Florence County Government
Procurement Department

**ADDENDUM NO. 1 - SPAULDING HEIGHTS COMMUNITY BUILDING ADDITION
(BID NO. 22-14/15)**

This addendum addresses the issues discussed at the pre-bid meeting. The revised attached plans shall replace the original bid document plans.

SPAULDING HEIGHTS RECREATION
CENTER ADDITION
FLORENCE, SC
FOOTING, FLOOR, & WALL PLANS

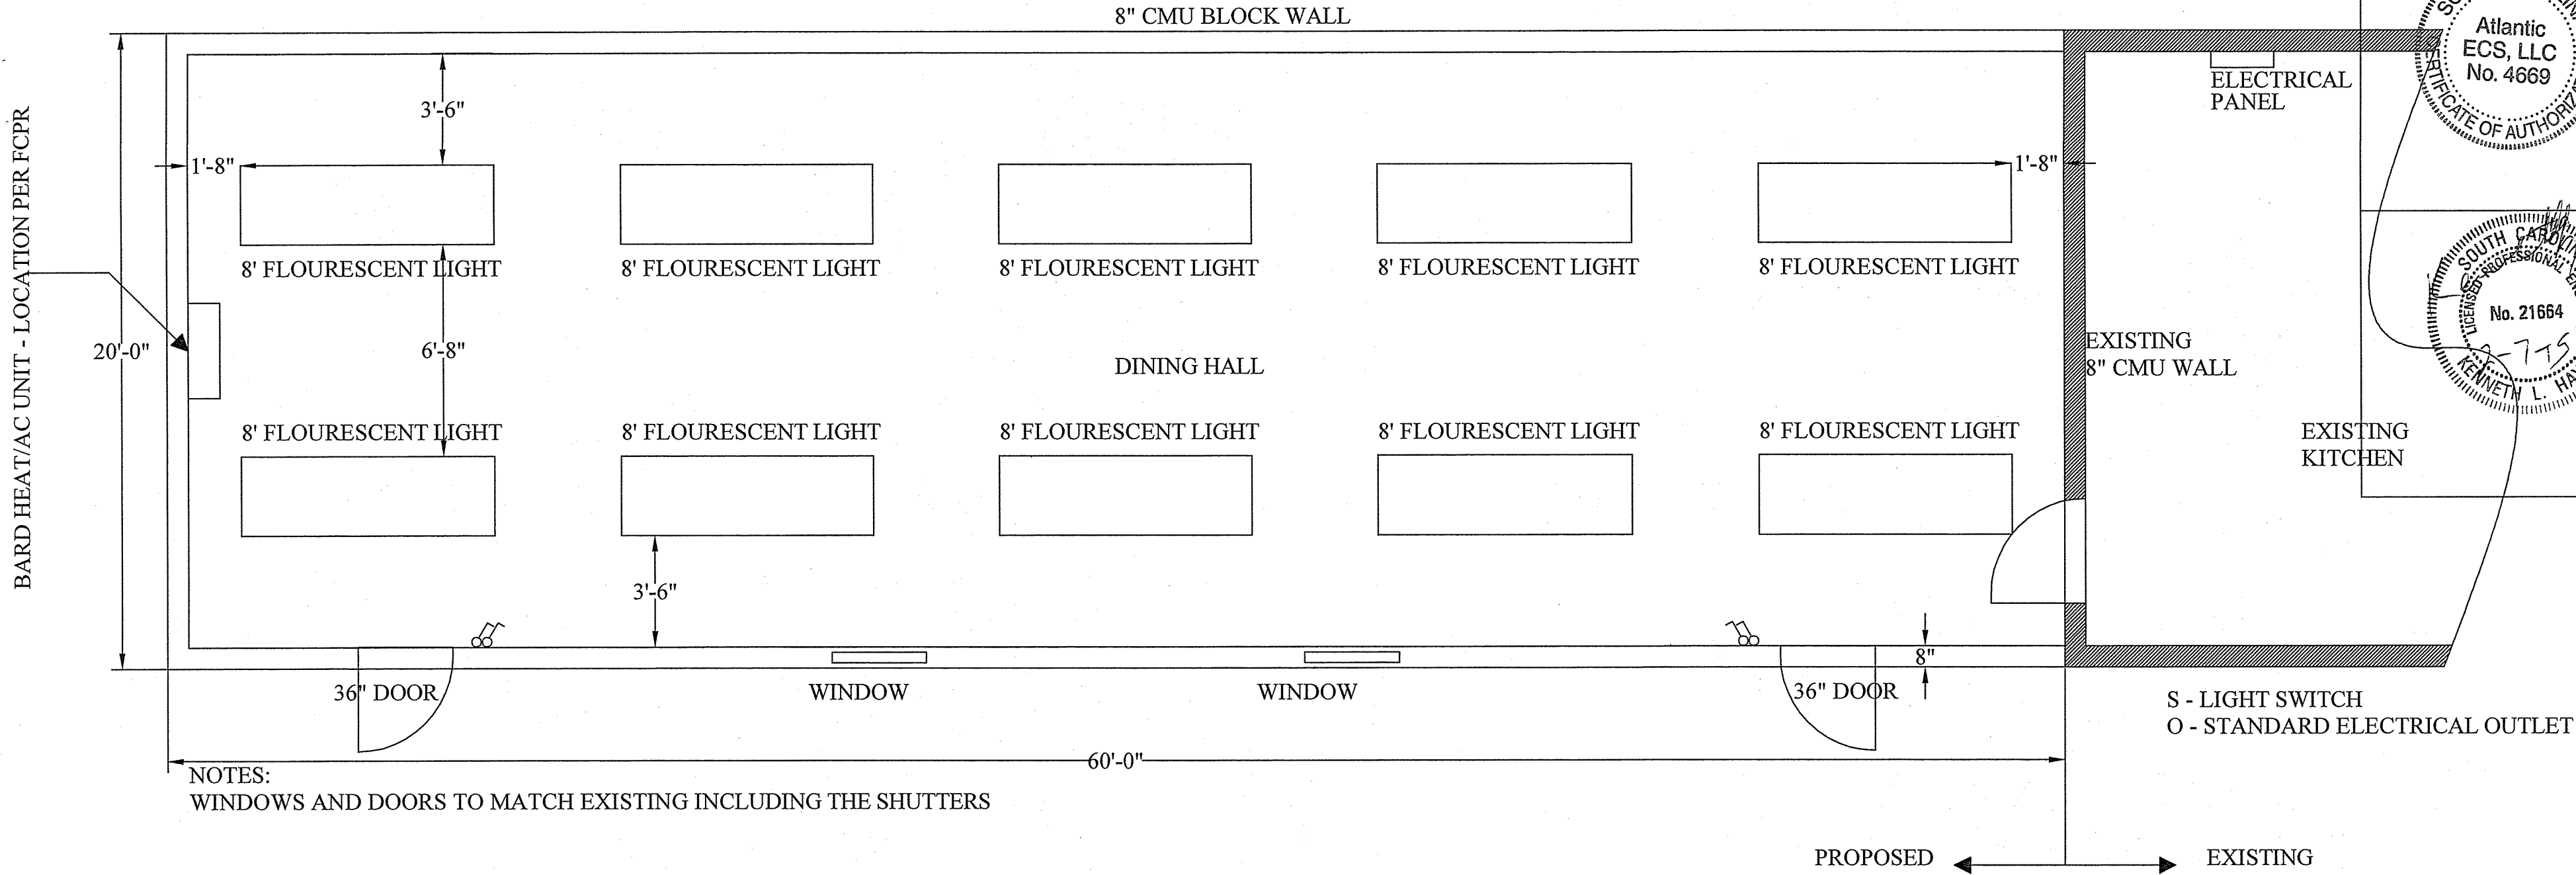
- The Contractor shall add partition (shutters, etc.) into the serving window to separate the addition from kitchen area. Reference plan Sheet S1, Note 3.

SPAULDING HEIGHTS RECREATION
CENTER ADDITION
FLORENCE, SC
FOOTING & WALL DETAILS

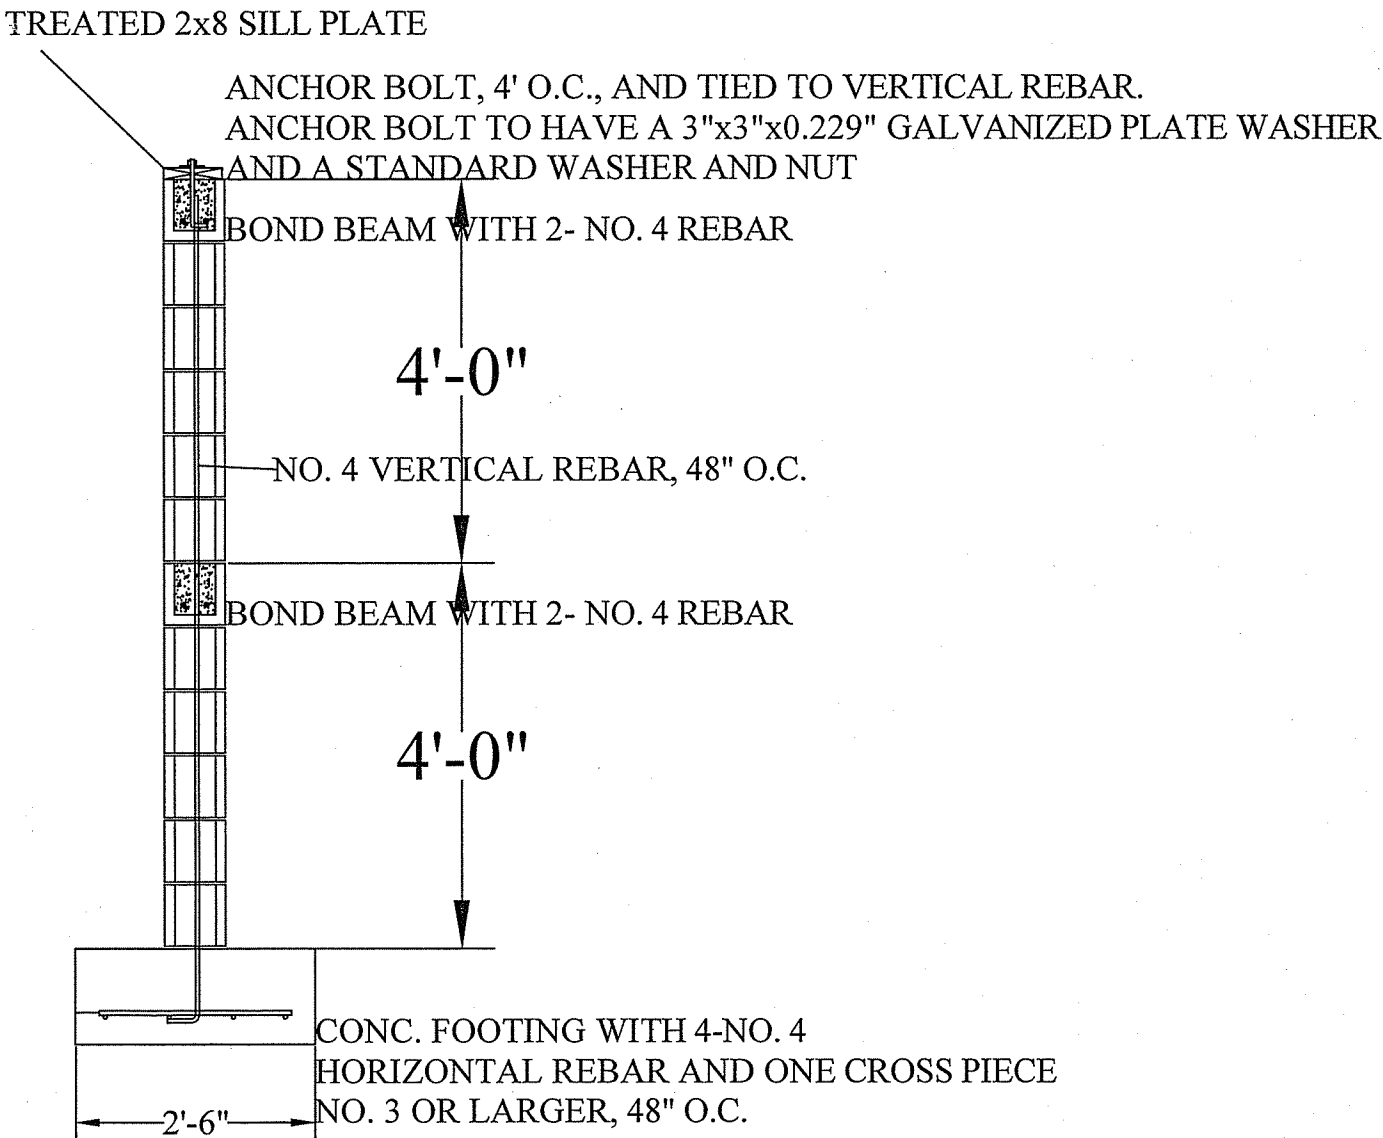
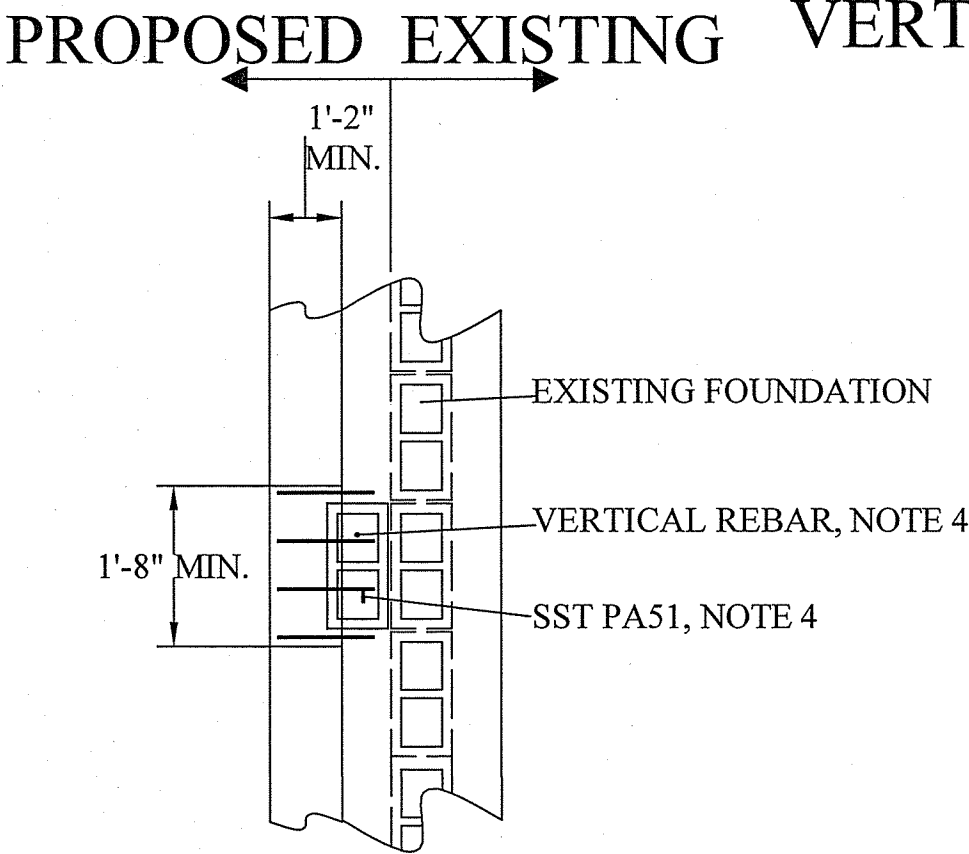
- The existing kitchen floor shall have the same new flooring as the addition.
- The sink shall be moved per the details in the revised plans.
- The concrete masonry unit (CMU) wall and floor slab detail have been revised, refer to the details in the revised plans.

SPAULDING HEIGHTS RECREATION
CENTER ADDITION
FLORENCE, SC
REMODELING PLAN

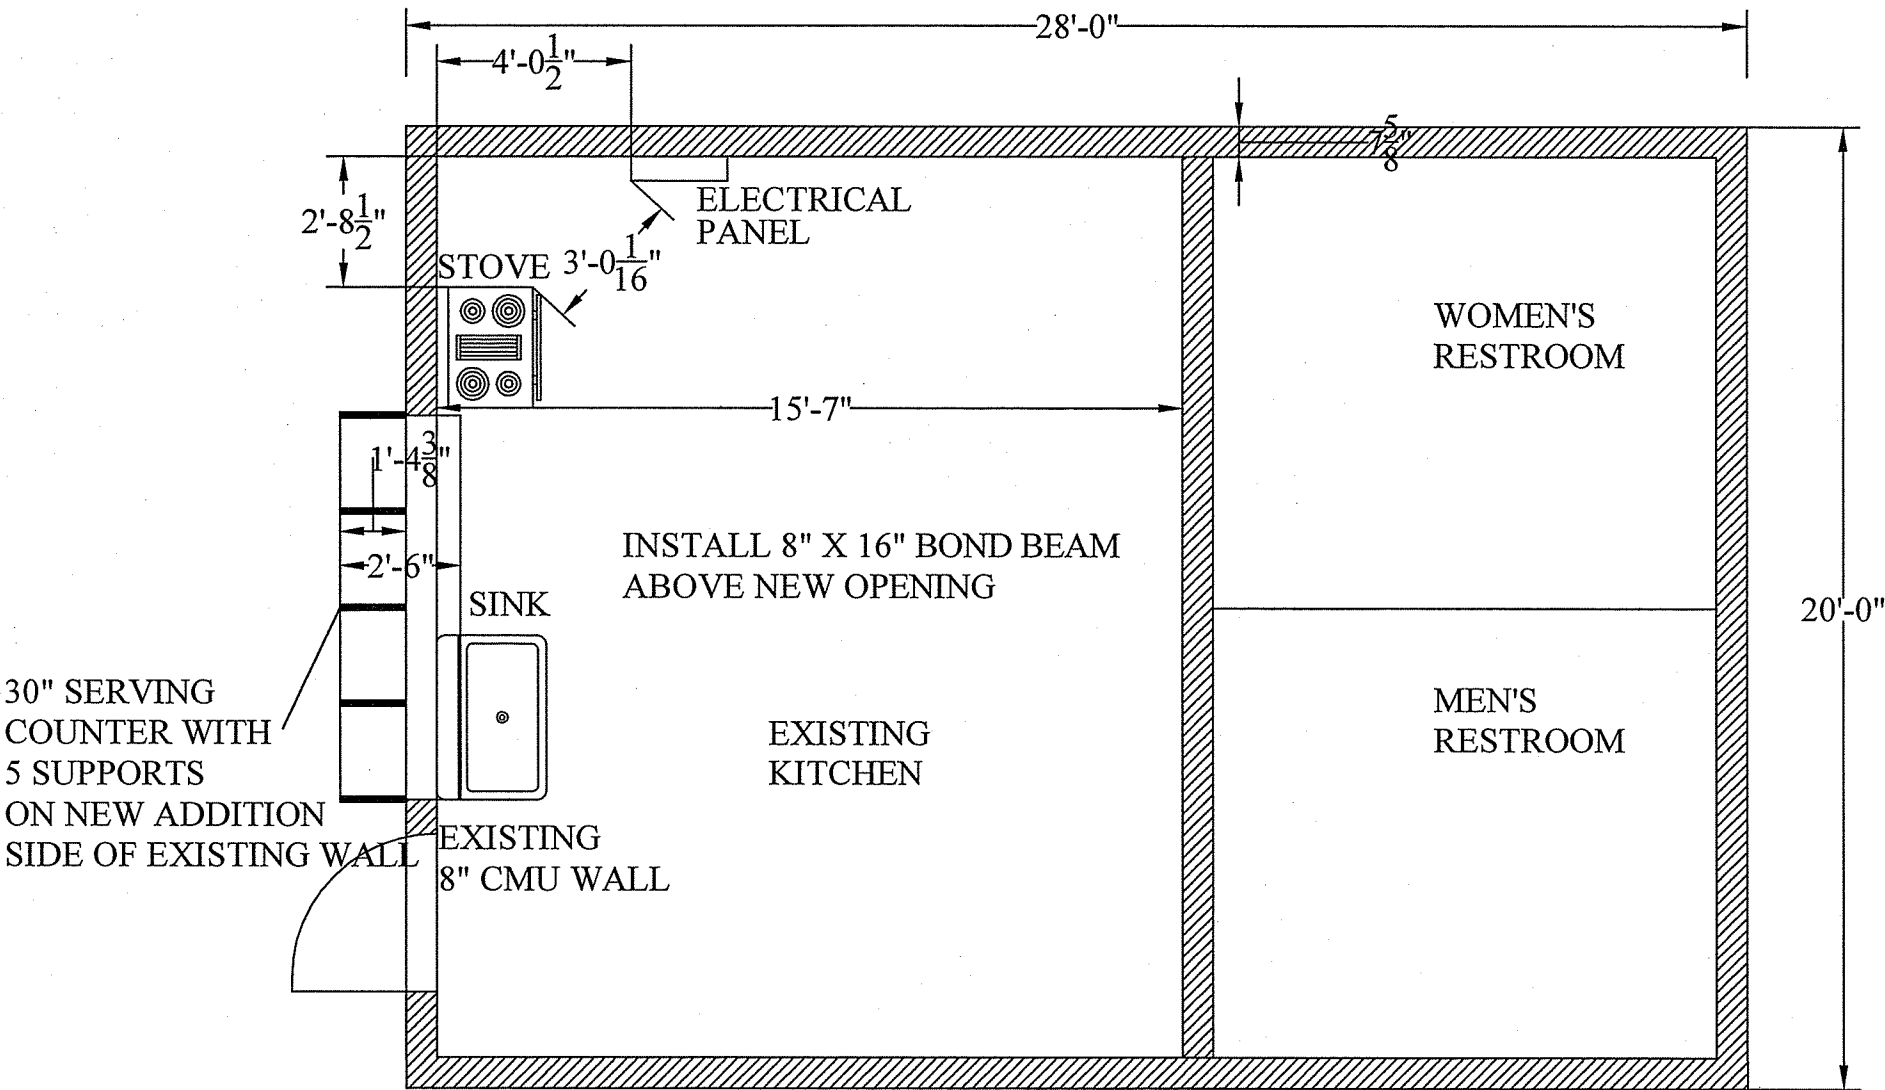
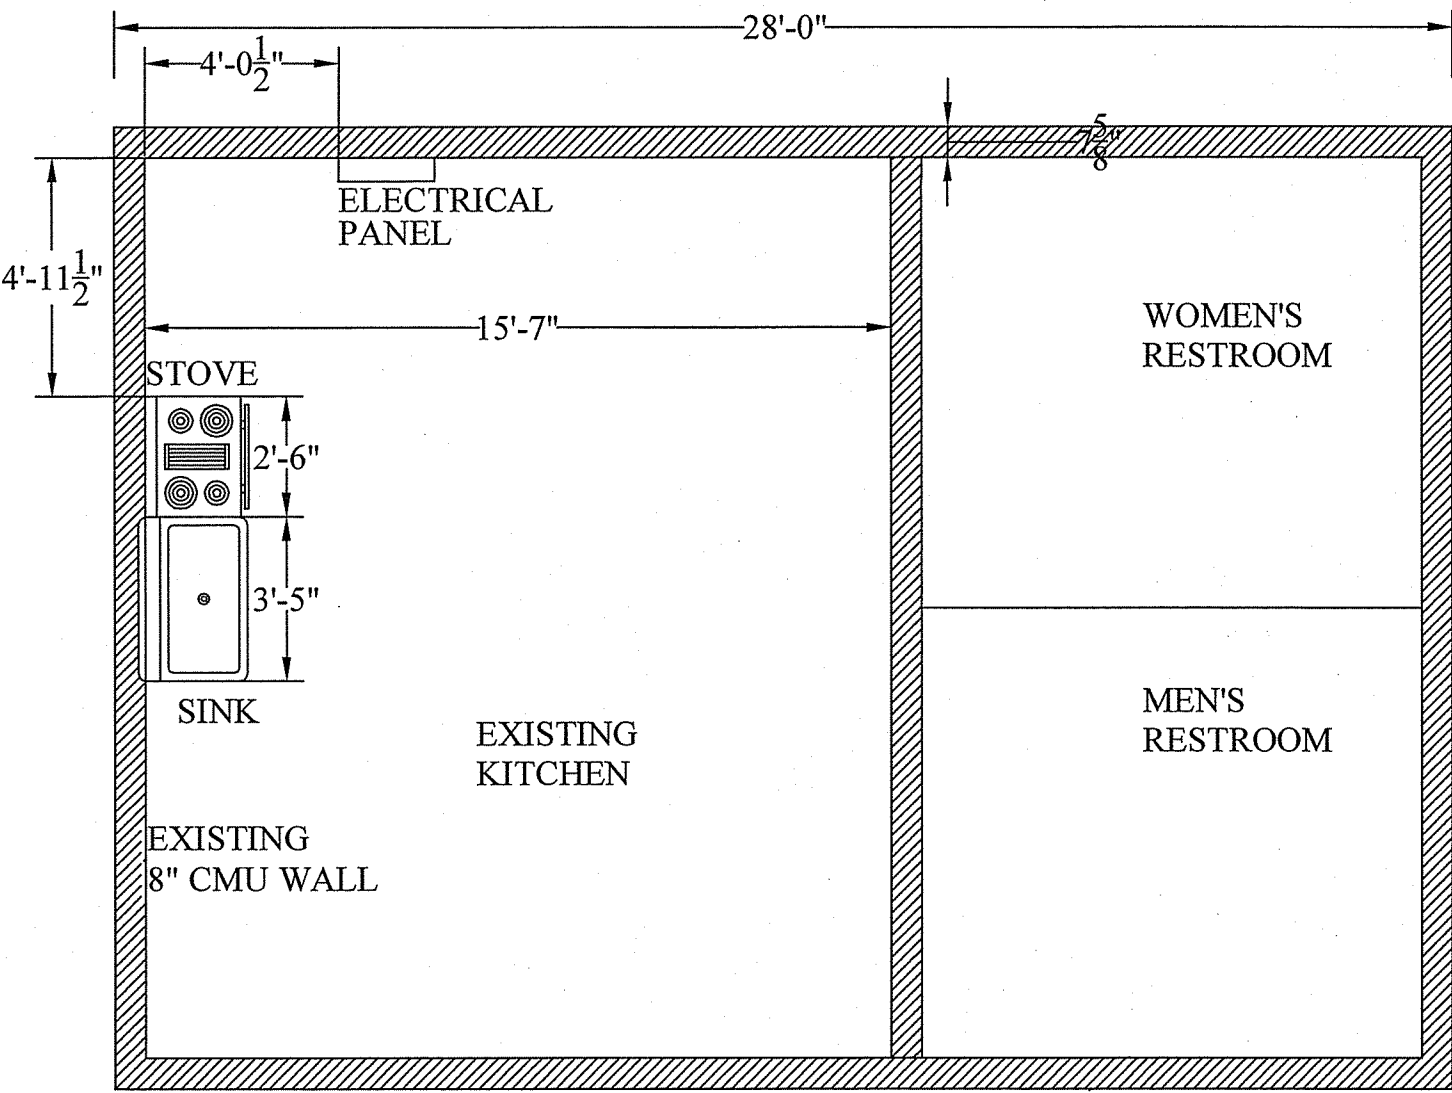
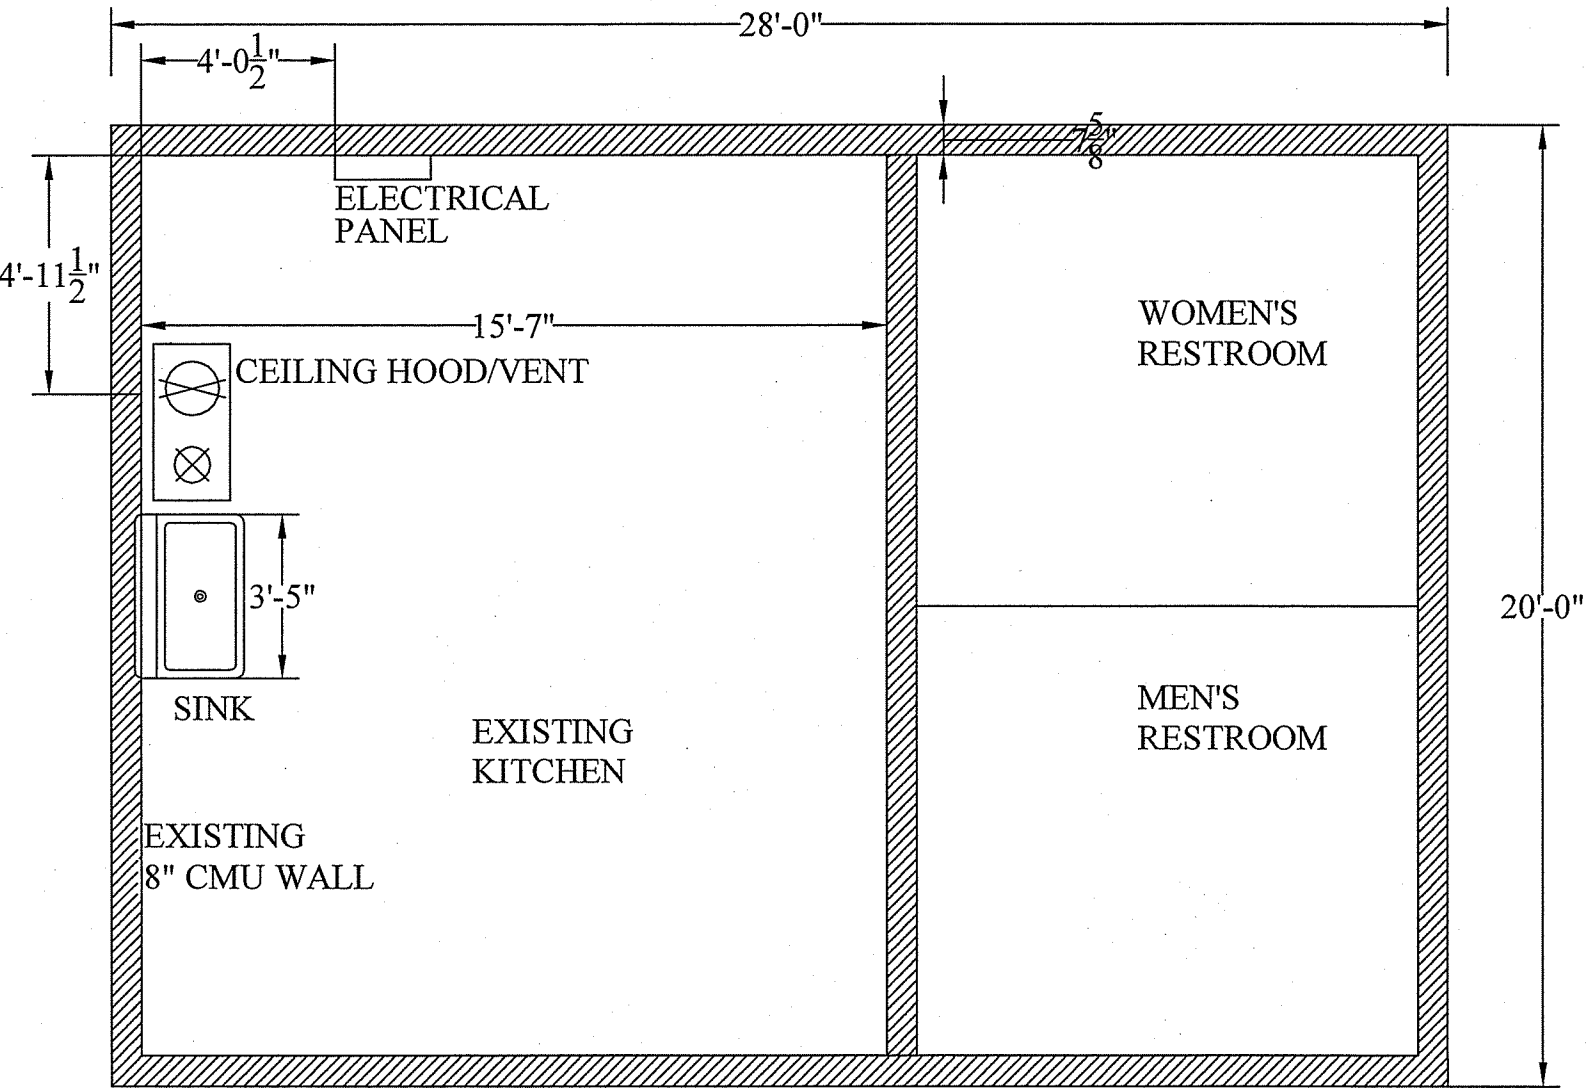
- The stove and sink are to be relocated per the revised S8 plan.
- The Contractor shall install attic access door in building addition. Refer to the plan sheet and scope of work note 1.
